Work Order ID 146117

Item Name: Conversion Squirrel Cheek Compatible (Fits LH or RH)

DART SERVICE INSTRUCTION

TO AMEND INSTALLATION INSTRUCTIONS D350-607-3 Rev.D,
INSTALLATION INSTRUCTIONS D350-607-4 Rev. C AND
INSTRUCTIONS FOR CONTINUED AIRWORTHINESS ICA-D350-607 REV. 6

FIGURE 1: INSTALLATION OF D4775-041 FWD STRUT

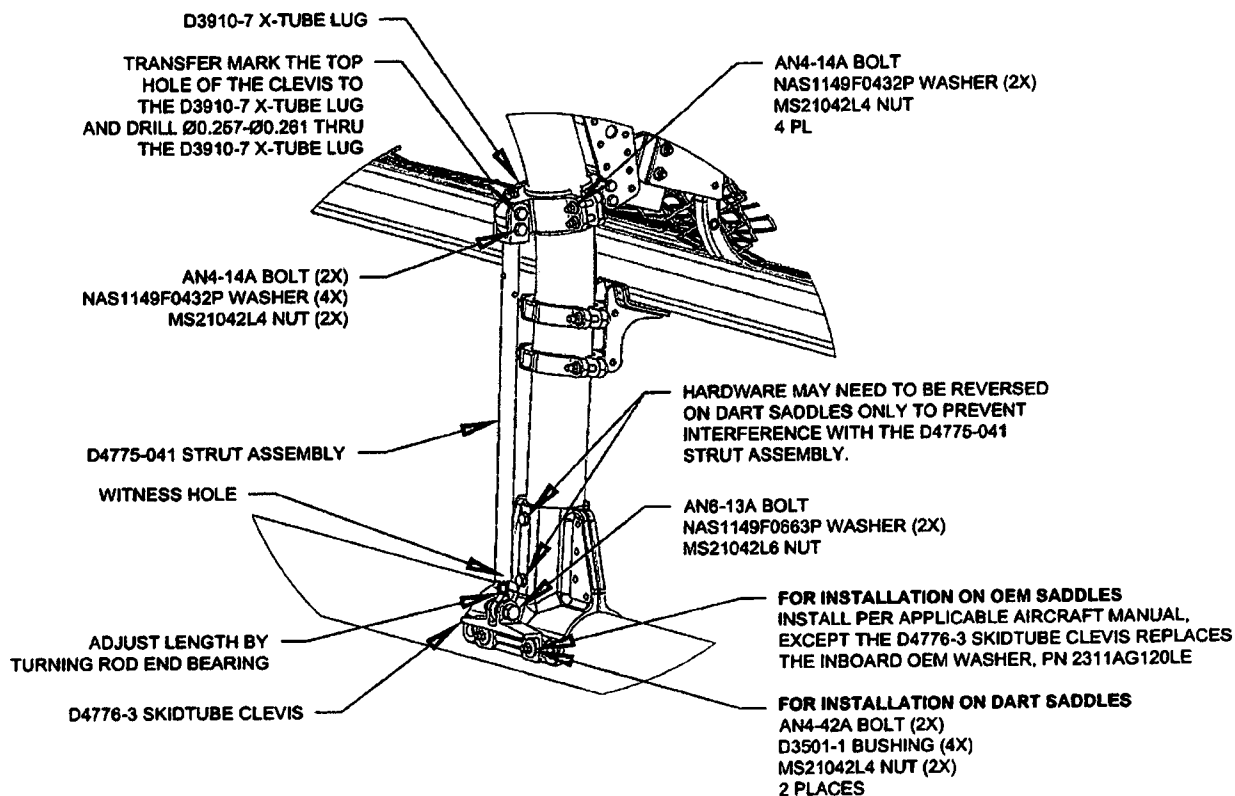
3.1 Substitute the Forward Lower D3910-5 X-Tube Lug with the D3910-7 X-Tube Lug as shown in Figure 1.

3.2 Install the forward D4775-041 Strut Assembly. Transfer mark from the upper hole on the clevis of the D4775-041 Strut Assembly to the D3910-7 X-tube Lug and drill thru the lug $\varnothing 0.257$ - $\varnothing 0.261$ as shown in Figure 1. Touch up chemical conversion coating per MIL-DTL-5541. Check the witness holes located at the bottom end of the D4775-041 Strut Assemblies to ensure that the thread from the rod end extends past the witness hole. Torque MS21042L4/-4 nuts to 50-70 in-lbs (5.7-7.9 N-m). Torque MS21042L6/-6 nuts to 160-190 in-lbs (18.1-21.5 N-m).
